Mobile Pentium® II Processor Specification Update

Release Date: August 1999

Order Number: 243887-013

The Mobile Pentium® II processor or the Intel® Pentium® II Processor Mobile Module may contain design defects or errors known as errata which may cause the product to deviate from published specifications. Current characterized errata are documented in this Specification Update.

Figure 2. Workaround Flowchart: SMBALERT#-Driven System

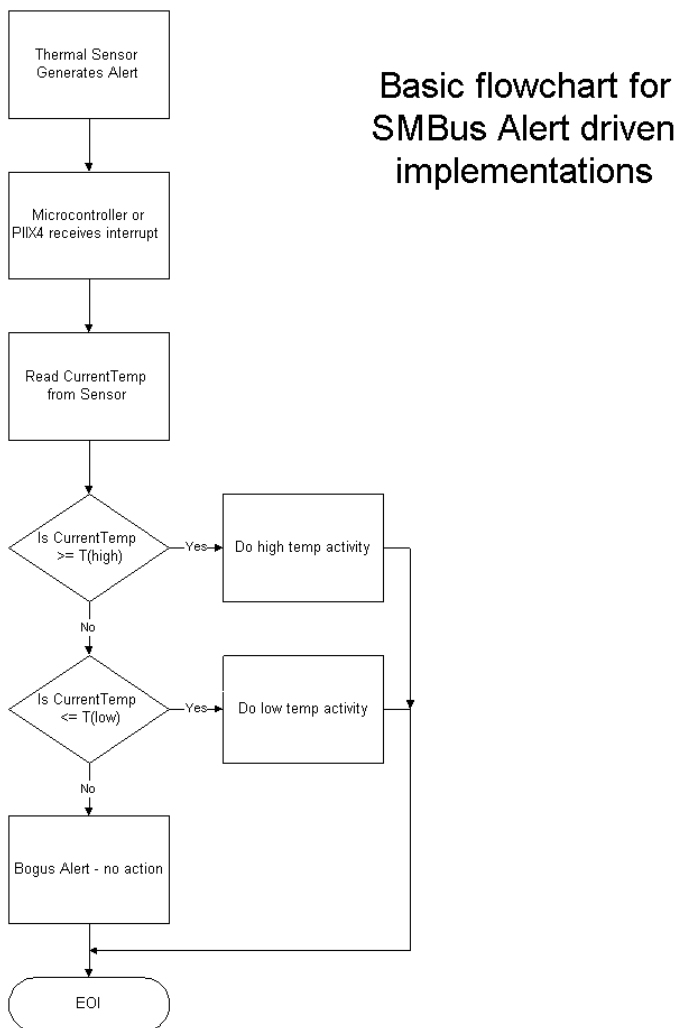
WORKAROUND: Three different (mutually exclusive) workarounds are possible:

1. Before servicing an interrupt from the thermal sensor, read and compare the processor thermal reading with the threshold limits (T_{HIGH} or T_{LOW}). Figures 2 and 3 provide basic flowcharts for the implementation of this workaround in an interrupt driven system.
2. If the firmware implemented polls the Status Register only, then before taking any action, re-read the temperature register and do a comparison with the alarm threshold limits (T_{HIGH} or T_{LOW}) to determine if the value is actually still within the temperature window.
3. Use a temperature polling scheme to monitor the processor temperature.

Figure 5.6. Cross Sectional View with Vertical Dimensions

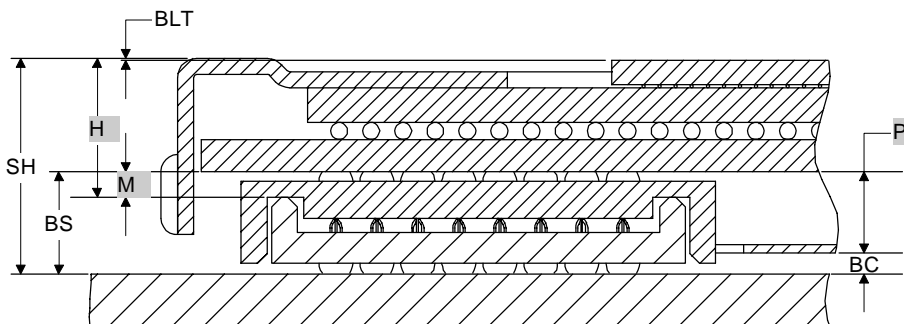
B1. Misabeled Vertical Dimension Parameters

Figure 5.6 in the *Mobile Pentium® II Processor at 233 MHz, 266 MHz, and 300 MHz* datasheet should be replaced by the following figure:

Figure 5.3. Surface-Mount BGA1 Package—Top and Side View

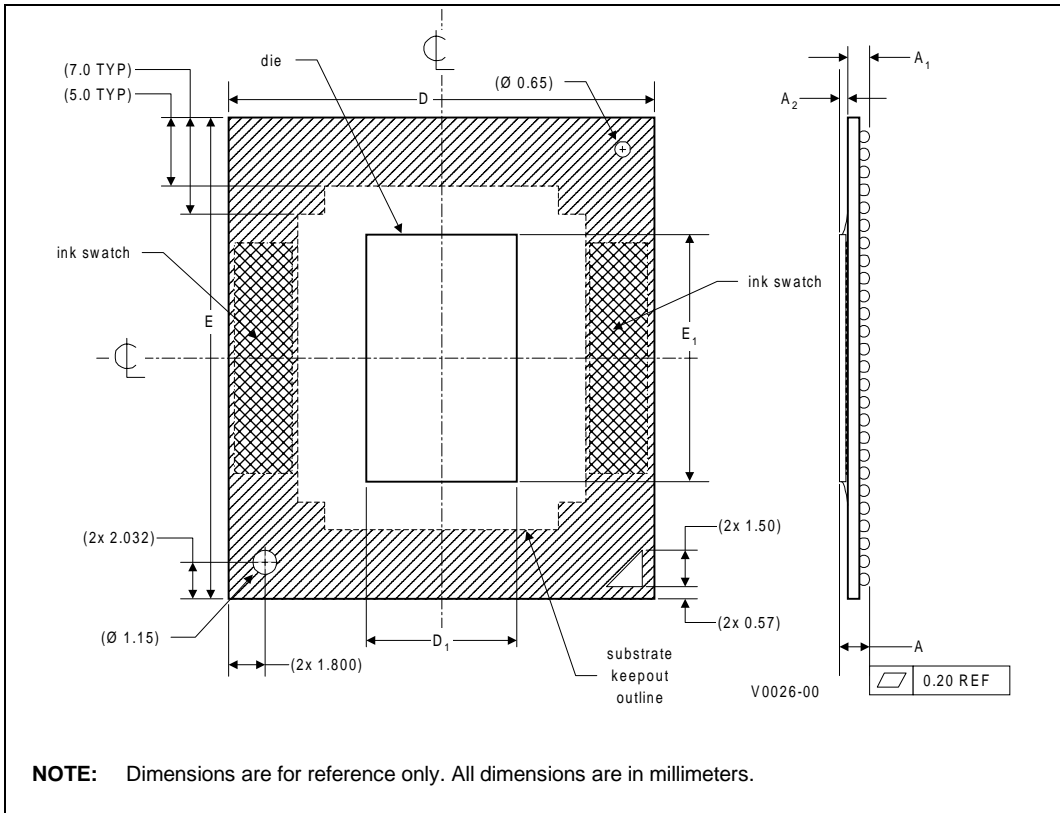
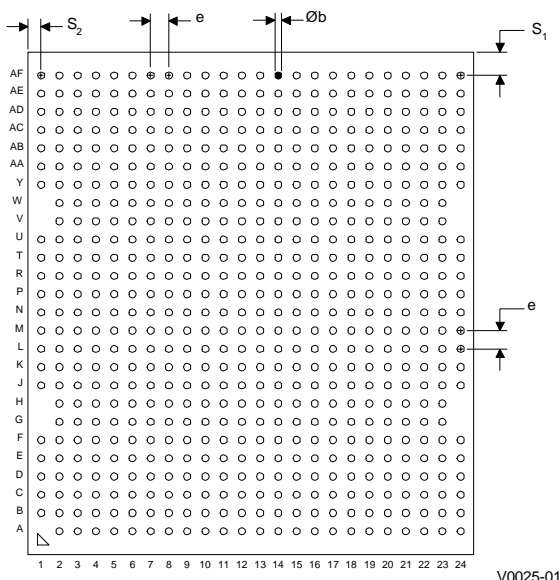
The following table and figures show the updated mechanical specifications for the BGA1 package, listed as Table 5.2, Figure 5.3 and Figure 5.4, respectively, in the *Mobile Pentium® II Processor in BGA Package at 366 MHz, 333 MHz, 300PE MHz, and 266PE MHz* datasheet.

Figure 3.3 Generic Clock Waveform

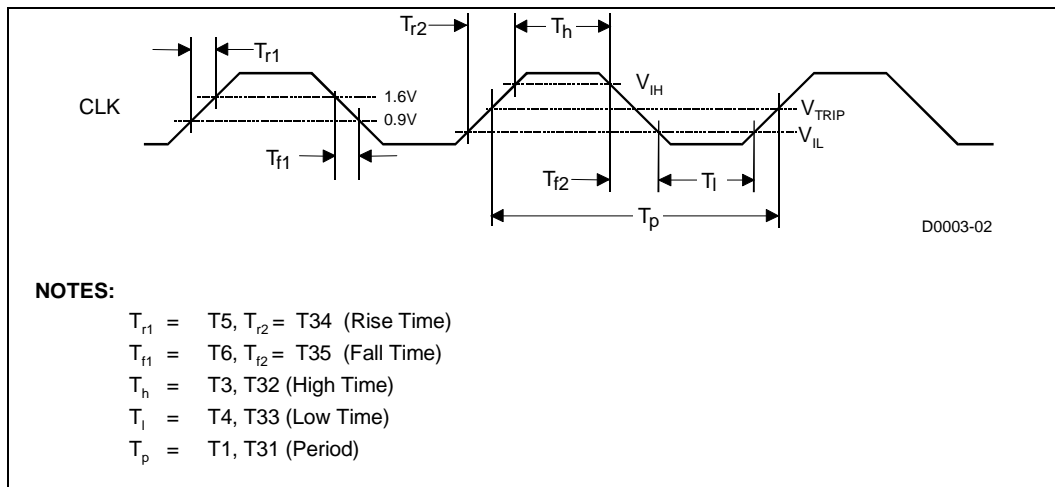
B14. Generic Clock Waveform Figure

Figure 3.3 in *Mobile Pentium® II Processor in Mini-Cartridge Package at 366 MHz, 333 MHz, 300PE MHz, and 266PE MHz* datasheet (Order Number 245108), and the *Mobile Pentium® II Processor in BGA Package at 366 MHz, 333 MHz, 300PE MHz, and 266PE MHz* datasheet (Order Number 245106) has been updated. The following figure is to replace the ones in the above documents.

Figure 1. TAP Gageable Thread Clarification

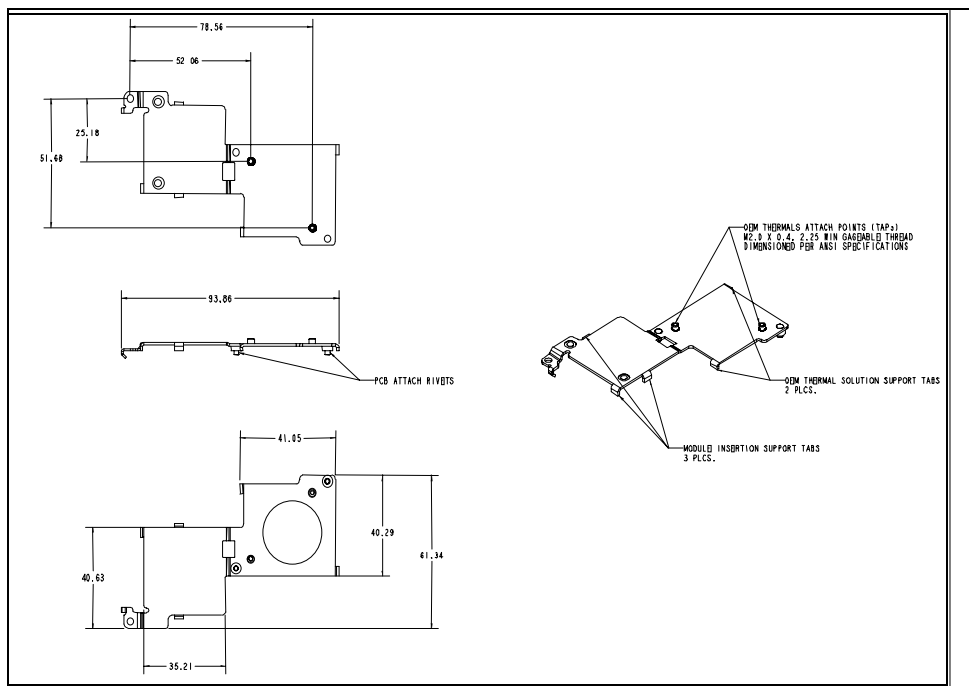
In the *Intel® Pentium® II Processor Mobile Module : Mobile Module Connector 1 (MMC-1)* and the *Intel® Pentium® II Processor Mobile Module : Mobile Module Connector 2 (MMC-2)* datasheets (Order Numbers 243667 and 243668, respectively), the thermal attach point (TAP) gageable thread specification was not clearly identified in Figure 14, of Section 5.2. The following is the TAP clarification:

OEM Thermal Attach Points (TAPs) M2.0 x 0.4, 2.25 min gageable thread dimensioned per ANSI specification.

See Figure 1 below for more information.
